I am writing to object to the proposed development at 6610-6706 Old Sauk. I understand that Madison has a housing crisis, and I do not object to the big apartment complexes that have gone up near Hildale, in downtown Middleton or in other walkable neighborhoods. I object specifically to this project, which violates many principles of good urban design. Yes, we have a housing crisis. But we shouldn't be responding to it by permitting building that destroys the environment, isolates people in enclaves, and more or less forces people into cars. Madison is supposed to be a progressive city; we should be pushing for progressive, high-quality urban design.

From: [Fun to Build](#)
To: [Plan Commission Comments](#)
Cc: Ledell.Zellers@gmail.com; [Guequierre, John](#); [Fruhling, William](#); [Parks, Timothy](#)
Subject: Re: Escalator Clause, Stone House Development Proposal for 6610-6706 Old Sauk Rd
Date: Friday, May 31, 2024 9:39:32 AM

Please post to Public Comments for Legistar #82950, 82972, 83477 and 82979 and for 6610 - 6706 Old Sauk Rd.

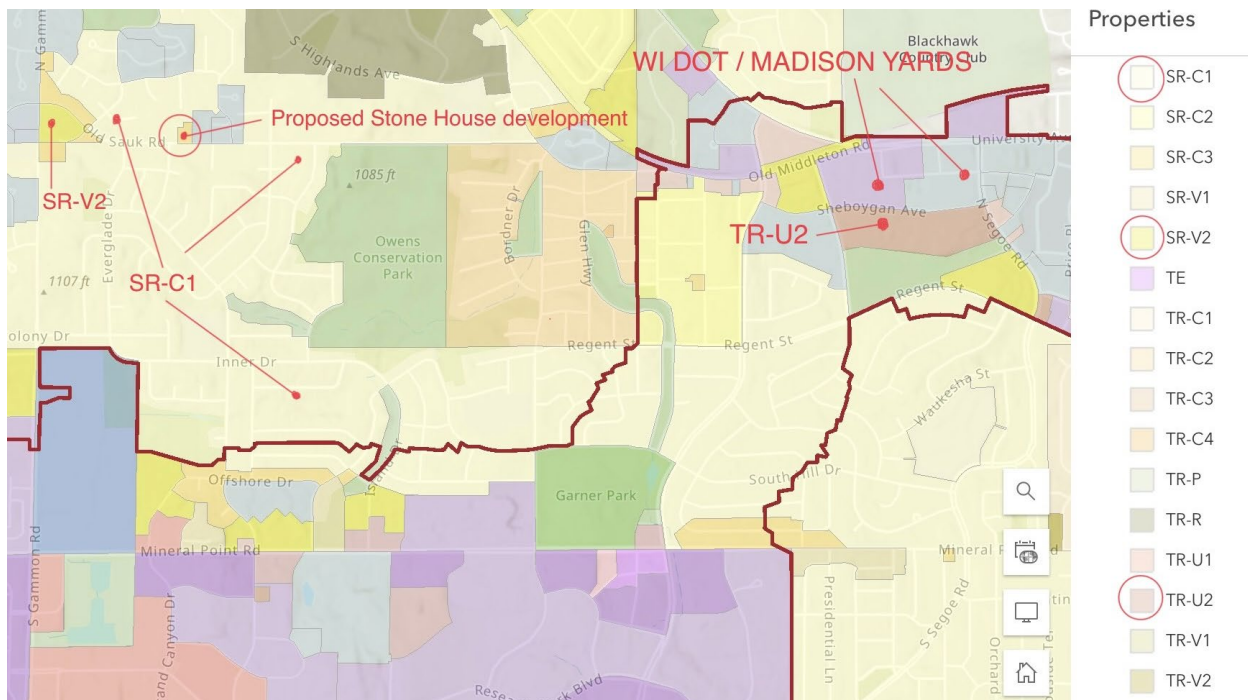
While I cannot speak for others, the main objections I have to this project are related to its high density and the request for a change to inappropriate zoning classification. There is, as I will point out a SR zoning classification that addresses multi family housing that could possibly provide a substantial amount of units. This SR classification is already present in the nearby area. As you must know, in its present form, I along with considerable number of others in the district remain strongly opposed to this out of proportion ill fitting project.

In looking at this zoning map I am curious about the change of zoning request from SR-C3 to TR-U2 for the Old Sauk Road development. TR-U2 zoning "Statement of Purpose" deals with high-density residential areas. There are exactly zero high-density residential areas anywhere near the proposed site for this project. The closest TR-U2 location is on Sheboygan Avenue. Its neighbors are WI DOT and the ultra high density Madison Yards development. I do not at all consider this request to be in anyway compatible with the existing character or zoning that surrounds this site and should be denied. Did the developer merely just look around for a zoning category that suited him?
